Application for Works Approval Amendment

Works Approval Number	W6449/2020/1
Works Approval Holder	GSM Mining Company Pty Ltd
ACN	165 235 030
File Number	DER2020/000457
Premises	Granny Smith Gold Mine Part of Mining Tenements M38/205 and M38/532 LAVERTON WA 6440 As defined by the Premises maps attached to the issued works approval
Date of Report	10/07/2023
Proposed Decision	Revised works approval granted

Figure 1: Zone B1 and B2 Arrangement

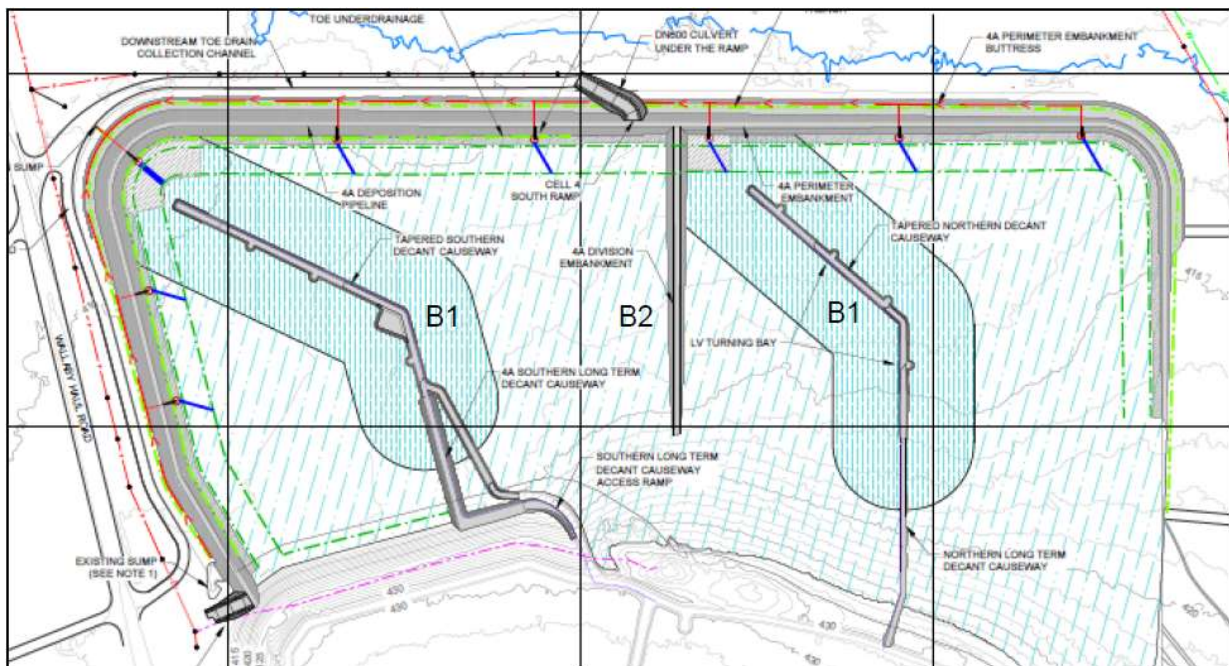
- permeability testing at 1 hectare intervals across the TSF basin to determine material placement;
- placement of a 300 mm thick liner comprising clayey construction material with permeability of 1.72×10^{-8} in zone B1 areas (Figure 1).

- relax the maximum permeability of the basin liner in the works approval from 2×10^{-8} m/s to 1×10^{-7} m/s. The proposed liner will be made from construction materials from Childe Harold Waste Dump and/or the Cell 2 TSF tailings beach:
 - in Zone B2 areas (70 ha) (Figure 1: Zone B1 and B2 Arrangement) a 300 mm layer of TSF Cell 2 tailings or Childe Harold waste (whichever has the lowest permeability) will be placed over the subgrade and compacted to $> 102\%$ standard maximum dry density (SMD). Zone B2 areas have a permeability is determined to be $> 1 \times 10^{-7}$ m/s;
- construct a temporary runoff diversion bund at the base of the TSF Cell 3 embankment to protect the liner areas from erosion while exposed.

Figure 6: Seepage flow through basin floor the different cases

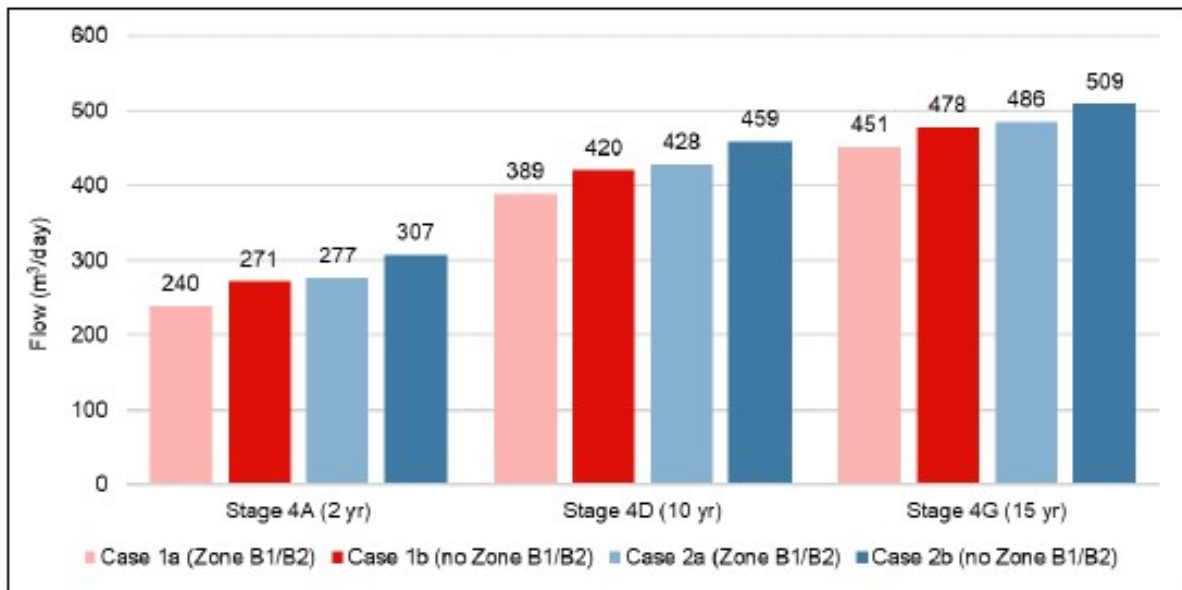
- Case 1a (liner and no seepage trench extraction), seepage flow estimate varies from 240 m³/day to 450 m³/day from years two to fifteen as shown in Figure 4.
- Case 1b (no liner and no seepage trench extraction), flow increases slightly from 271 to 478 m³/day from years two to fifteen.
- Case 2a (toe underdrainage and seepage inception trench with liner) and 2b (Toe underdrainage and seepage interception trench without liner), the seepage rates increased on average 10%. This is due to the reduced pressure head in the Ferricrete.

Case 2a and 2b were selected to be implemented by GSM to reduce seepage.

Figure 6 shows that extraction from the trench reduces the flow to less than half of the expected downstream seepage. The presence of a liner in Cell 4 is expected to have a limited impact to reducing seepage flow through ferricrete (<5% total flow).

Figure 7: Seepage flow through ferricrete downstream of the embankment for the different cases

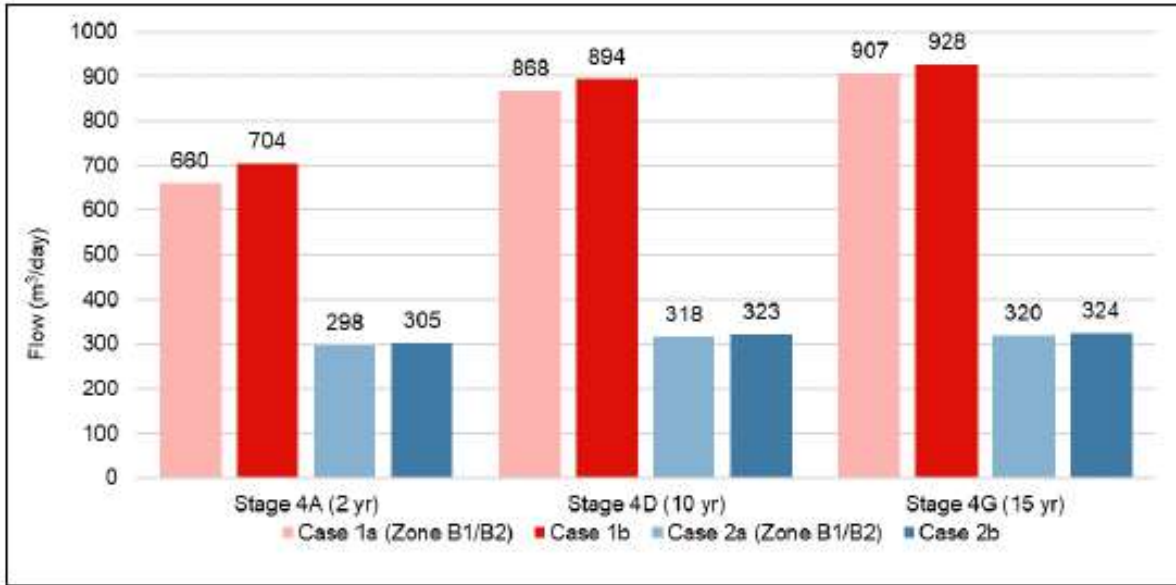
Once tailings begin to seep through the basin floor of the TSF, it will have a lateral flow through the fractured ferricrete in the foundation that will combine with lateral flow generated from Cell 3. Figure 5 below shows the comparison of water flow downstream through the ferricrete for the scenarios without (case 1a/1b) and with (case 2a/2b) the interception trench.

Expected seepage through the ferricrete downstream to Cell 4 with the upstream drainage and the seepage interception trench active is expected to be 300 to 330 m³/day throughout the life of Cell 4.
